DUKE POWER COMPANY

Re: McGuire Nuclear Station
Docket Nos. 50-369, 50-370

McGuire Nuclear Station Supplemental Information on Steam Generators Related to D2/D3 Modification

McGuire Nuclear Station
Feedwater System Changes
AUX FDW

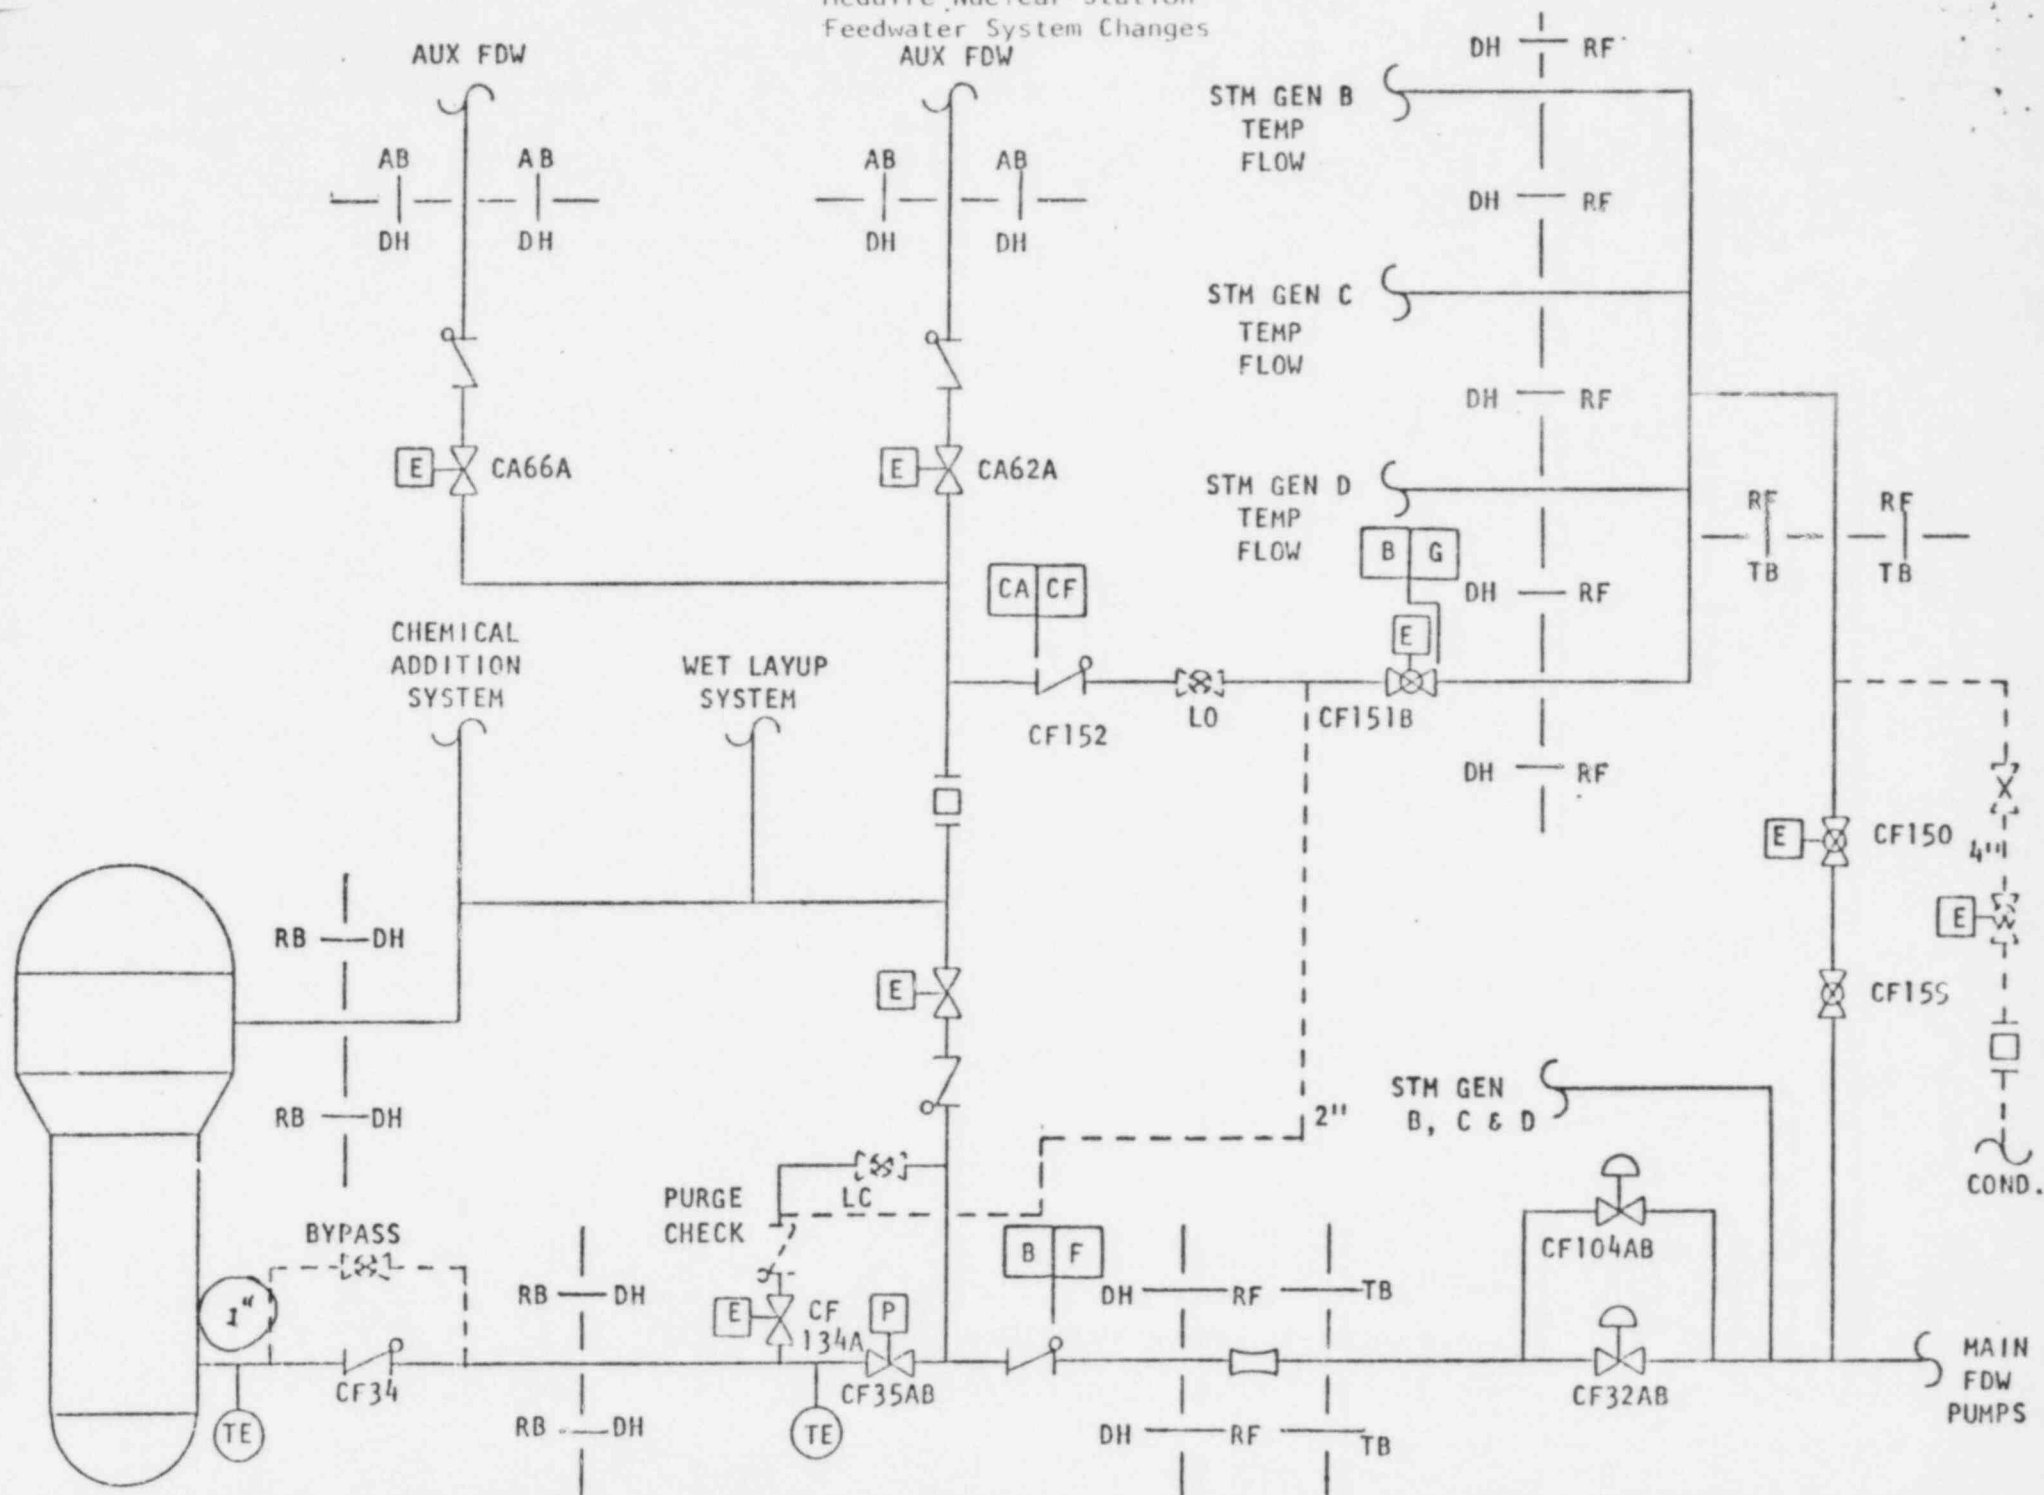
The modification to the feedwater system as shown in Figure 2 of the February 3, 1983 submittal showed a 2" bypass line around the check valve in the main feedwater system adjacent to the steam generator. This drawing was in error since the bypass is a 1" line. Attachment 3 is a corrected copy of this figure. The modification to the feedwater system to permit backflushing of the feedline will also be installed on Unit 2.
